Access Compliance Report

Public Rights-of-Way

(Curb Ramps)

| Intersection ID: 18012 | Main Street: RAMA_RD | Cross Street: CHARING_PL | Location: SW |

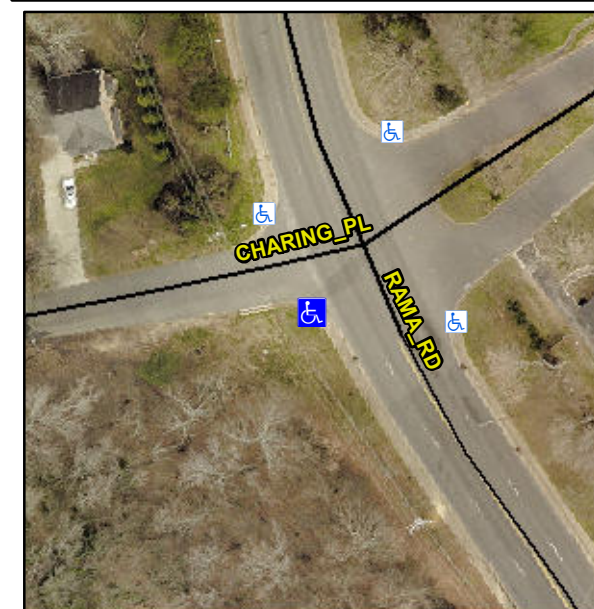
Not Found, R304.5.1, R304.2.2

| Compliance | Description | Data | Compliance | Description | Data |
|------------|-----------------------|-------|------------|-----------------------------|-------|
| N/A | Ramp Length (in) | 60.5 | No | Ramp Slope (%) | 10.5 |
| No | Ramp Width (in) | 47.5 | Yes | Ramp XSlope (%) | 0.3 |

Remove & Replace Curb Ramp With Two New Directional Ramps or Equivalent.
